# PLAN 2

## The Holly - RH

### 'ENGLISH COUNTRY' ELEVATION

Lot 13 WS - 34 Avents Creek Way, Fuquay-Varina, NC 27526

**EXTENDED CAFE W/ COVERED PORCH PLAN**  
SCALE: 1/8"=1'-0" ON 11x17, 1/4"=1'-0" ON 22x34

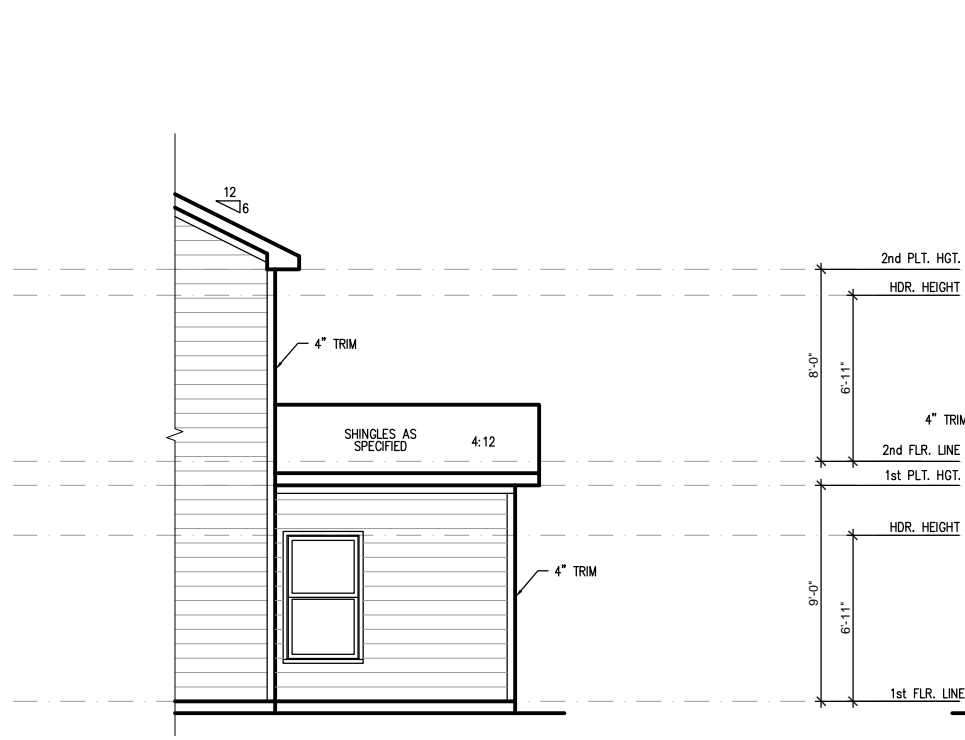
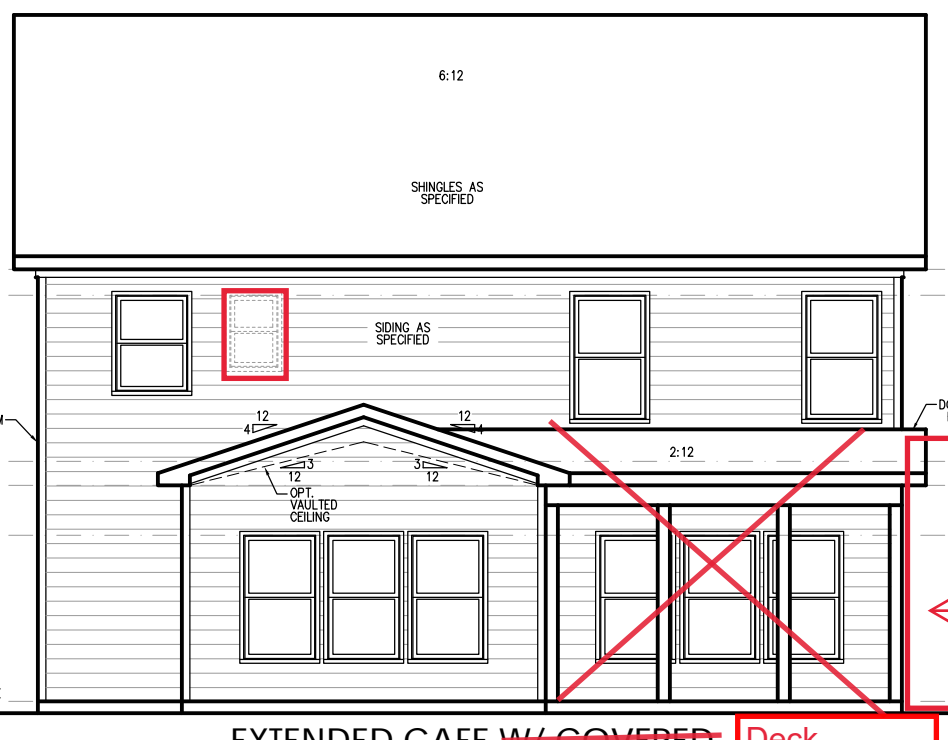
Add Fireplace bumpout
